PLANNING APPLICATION PLN-20-0176

96-102 FAIRLOUGH STREET (APPROVED LOT 30, WILL BE 102 FAIRLOUGH STREET), PERTH

Description of proposal: ..... New 7-bedroom dwelling with deck & landings

**Additional Information Required for Planning Application PLN-20-0176  
Communal Residence at 96-102 Fairtlough Street, Perth (on Lot 30 approved by permit PLN-19-0184)**

CONSTRUCTION PLAN  
 SCALE 1:100

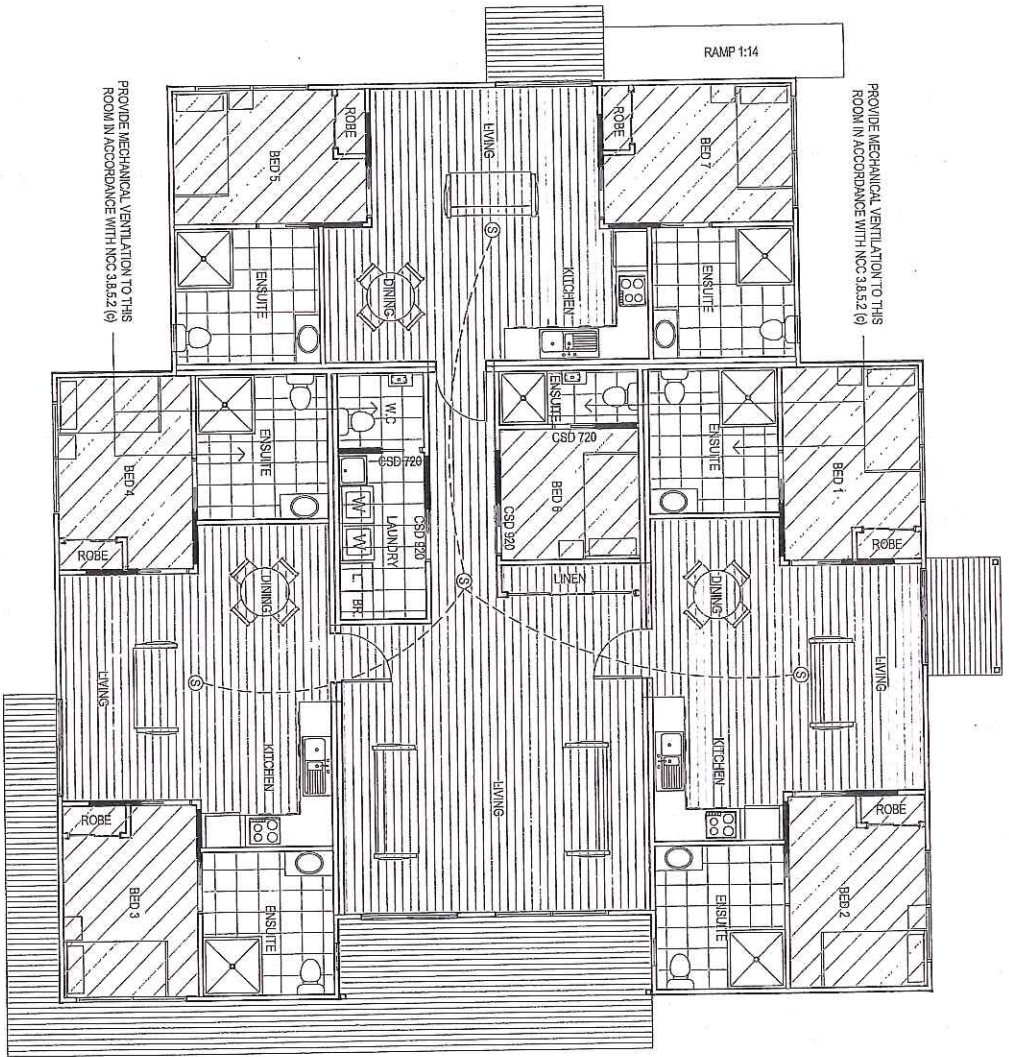
The planning scheme requires a 5m setback from Fairtlough Street. It will be difficult to recommend approval of the proposed 3.5m setback. However I could support a 4.5m setback (as it would be compatible with the setbacks that would be required for the adjoining properties) providing the street elevation is made more compatible with the residential environment by, for example, giving the windows a vertical orientation, including a bedroom window to the south of the front entrance, and including a 0.6m deep awning/roof (which may be within the 4.5m front setback) over the front entrance.

3. 10.4.2 (A1) – Setback from front boundary in the planning scheme is 4.5 metres. This proposal has a setback of 3.11 metres. The planning scheme states 4.5 metres unless an eaves, steps, awnings and porch, can extend not more into this area by only .6 of a metre. The porch extends 1.39 metres into the exclusion zone. All other residences in the street will need to comply to the 4.5 metre setback, making this one stand out.
